# SERVICE BULLETIN

**TO:** AUTHORIZED NORTH AMERICAN STANDBY DEALERS  
**BULLETIN:** DSB-1115 Rev. A  
**DATE:** SEPTEMBER 2020  
**SUBJECT:** GC-1031 CONTROLLER I/P SENSE LOSS FAILURES  
**MODELS:** 12KW, 17KW, 20KW  
**SERIAL NUMBERS:** SEE MODELS CHART

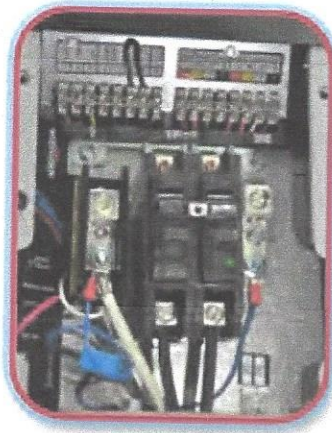
Dealers have encountered I/P Sense Loss failures on GC-1031 controllers, which could cause generators to shutdown.

- Check the sense wire by the generator circuit breaker to make sure a good connection is made. Check that the wire insulation is not pinched in the circuit breaker screw.

- Upgrade the firmware to the latest version (revision 7.04). Please follow the instructions found at <http://www.thepowerportal.com>. [Click here](#) to be rerouted to the GC-1031 controller firmware page. The usual warranty will apply for this update.
